SUBJECT: Reduction of Level Build-Up between selections on Extended Play Records when used on Model 2500 Phonographs.

The following wiring diagram shows the mute socket wiring before and after the wiring change.

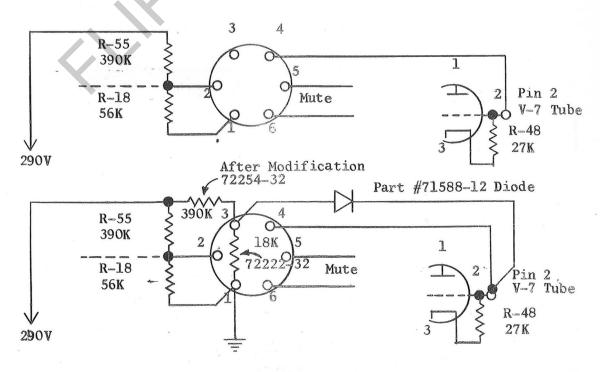
Complaints have been received, where E. P. Records are in use, that at times the second selection starts playing at a noticeably higher level then cuts back to normal. This is caused by the interval between selections, when no music is being played, allowing the automatic level control circuit to increase the output of the amplifier. The second selection then starts at the higher level and is gradually reduced to the pre-set level of the loudness control.

A change in wiring, using two additional resistors and one silicon diode, has been incorporated in the current production. To revise early model amplifiers it will be necessary to order one Silicon Diode, Part No. 71588-12, one 390K 1/2 Watt Resistor, Part No. 72254-32 and one 18K 1/2 Watt Resistor, Part No. 72222-32, for each amplifier.
